# Access Compliance Report

## Public Rights-of-Way

Intersection ID: 3365	Main Street: CRAYTON_DR	Cross Street: FAIRLEA_DR	Location: SE
ADA ID: 2A66B7CFA5C5	Ramp Type: BlendTrans1	Initial Pass/Fail: Fail	Overall Compliance: No
		Severity Score: 12.5

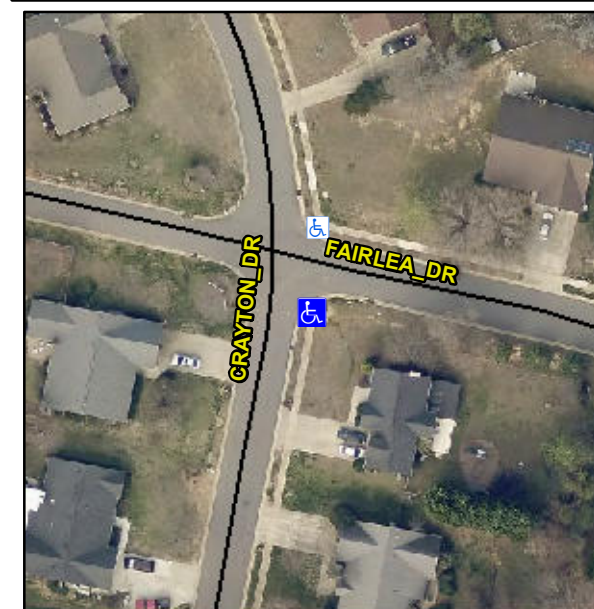
**Not Found, R304.5.3**

Compliance	Description	Data	Compliance	Description	Data
N/A	Ramp Length (in)	51.0	Yes	BlendTrans Slope (%)	2.3
Yes	Ramp Width (in)	48.0	No	BlendTrans XSlope (%)	6.5
N/A	Flare Type LT	N/A	N/A	Flare Type RT	N/A
N/A	Flare Slope LT (%)	N/A	N/A	Flare Slope RT (%)	N/A
N/A	Flare Traversable LT?	N/A	N/A	Flare Traversable RT?	N/A
N/A	Landing Length (in)	N/A	N/A	DWS Provided?	N/A
N/A	Landing Width (in)	N/A	N/A	DWS Contrast?	N/A
N/A	Landing Slope (%)	N/A	N/A	DWS Length (in)	N/A
N/A	Landing X Slope (%)	N/A	N/A	DWS Full Width?	N/A
N/A	Landing Curb? (Y/N)	N/A	N/A	DWS Offset (in)	N/A
N/A	Shared Landing?	N/A			
N/A	Gutter Ponding?	N/A	N/A	Gutter Slope (%)	N/A
N/A	Gutter Lip Ht (in)	N/A	N/A	Gutter X Slope (%)	N/A
N/A	Painted X Walk1?	No	N/A	Painted X Walk2?	N/A
	X Walk 1 Direction	To N		X Walk 2 Direction	N/A
	X Walk 1 Width (in)	N/A		X Walk 2 Width (in)	N/A
	X Walk 1 Slope (%)	3.4		X Walk 2 Slope (%)	N/A
	X Walk 1 X Slope (%)	1.6		X Walk 2 X Slope (%)	N/A

N/A	Ramp inside XWalk1?	N/A	N/A	Ramp inside XWalk2?	N/A
	Road Slope (%)	1.6		Clear Space?	N/A
	Road X Slope (%)	3.4	N/A	Clear Space to XWalk (in)	N/A
N/A	Any Obstructions?	N/A	N/A	Storm Grate/Utility Hazard?	N/A
	Obstruction Type			Storm Grate/Utility Type	
		N/A			N/A
			Yes	Surface Condition? (G/P)	Good
			No	Curb Slope (%)	6.8

**Remove & Replace Curb Ramp With Two New Directional Ramps or Equivalent.**
